Regarding DA number 2024/1835

ADDRESS: 10-12 CLIFFORD AVENUE, 33-35 FAIRLIGHT STREET, FAIRLIGHT
PROPOSED DEMOLITION & CONSTRUCTION OF NEW RESIDENTIAL
FLAT BUILDING

Extract of Low & Mid-Rise Housing Policy Indicative Map

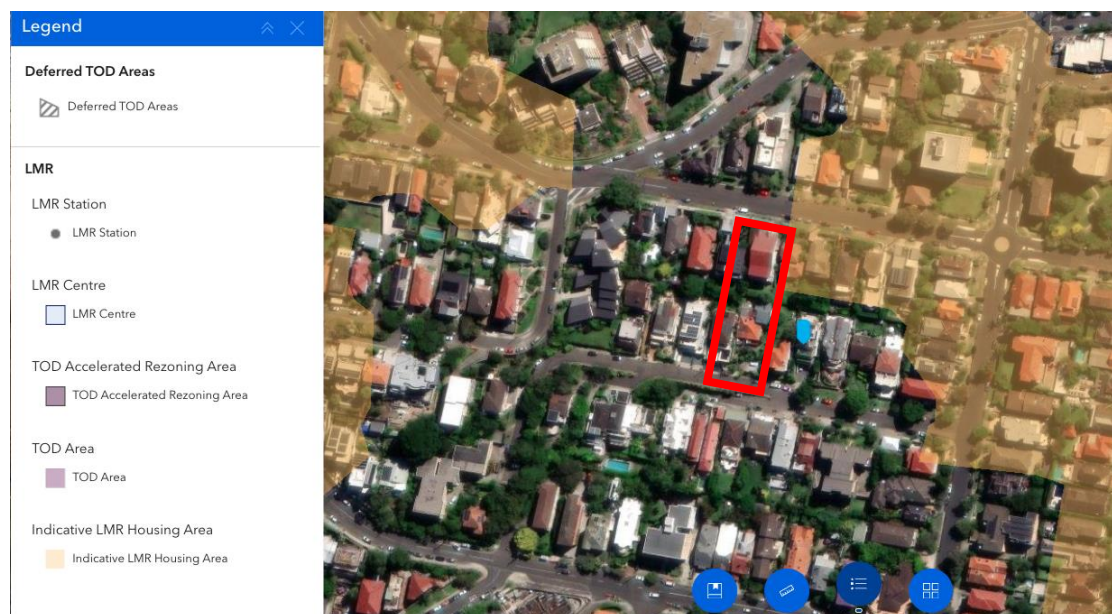
It is noted that the southern most properties of the development site, No. 10-12 Clifford Avenue) are specifically NOT included in the map relating to the NSW Governments Stage 2 Low & Mid Rise Housing Policy.

Therefore, this portion of the property will not benefit from any additional height or floor space controls. Further, the two properties on Fairlight Street (33 & 35) are actually outside the 800m radius from Manly Wharf.

Extract of Council Stormwater Map

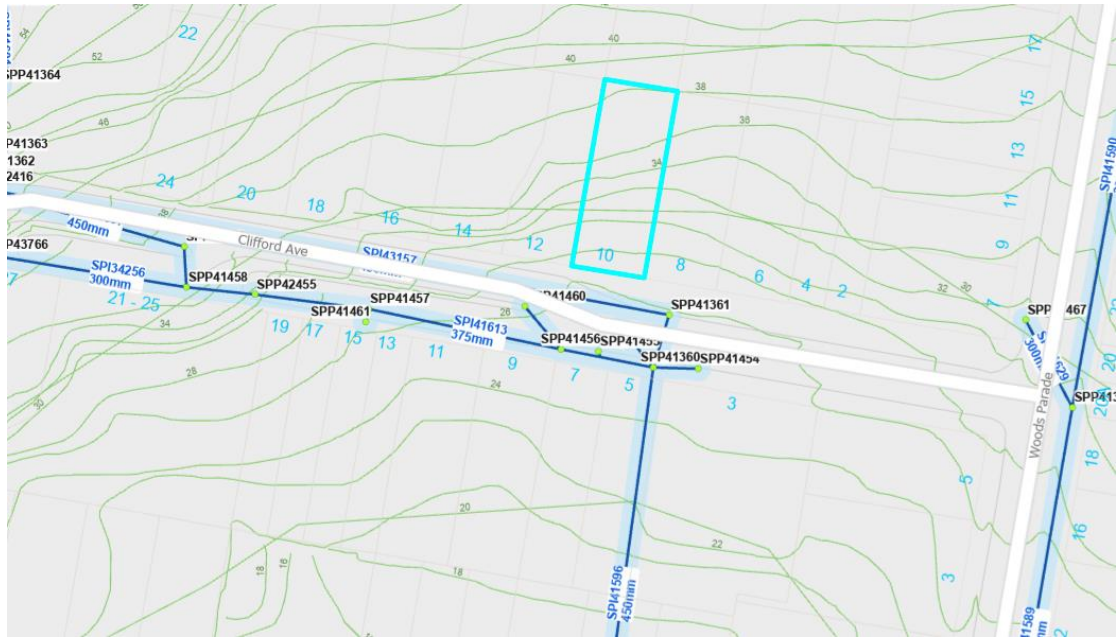
The Council's Stormwater Infrastructure Map depicts that stormwater from Clifford Avenue is conveyed downstream via a stormwater pipe that extends beneath No. 5 Clifford Road.

The concentration of all stormwater from the properties on the northern side of Clifford Avenue as well as the road drainage results in localized flooding, which affects No. 5, 7 and 9 Clifford Avenue. This flooding is identified on Council's flood hazard map.

There is concern that the proposed development will further add to the flooding. It has not been demonstrated that the existing drainage infrastructure can support the proposed development and associated runoff.
